404, DSP, DSH

Carrier Mounting Flange Design Change

Axle Housing Fasteners

Thick Flange - After 6/3/02

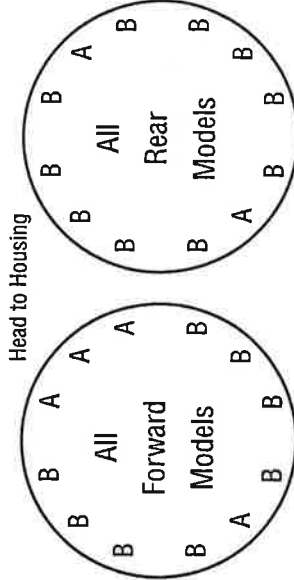
On June 3, 2002 the DSP40(P), DSP 41(P), DDP40(P), DDP41(P), RSP40, RSP41, RDP40 and RDP41 models were upgraded to the new "Thick Flange" carrier design as fully detailed in Dana bulletin AXIP-0210R1. Shown below are the axle housing hardware kits and fastener locations for both variations. View fastener locations as if installing differential into the axle housing.

Note: GM models require a special double-ended capscrews. They continue to use carriers with the original design thin flange. At this time Dana does not have a double-ended capscrew for "Thick Flange" models.

- A - 127641 Studs & 127567 Nuts
- B - 130836 Capscrews - Short (45 mm)
- C - 130837 Capscrews - Long (70 mm)
- D - 130877 Flat Washers - All Locations
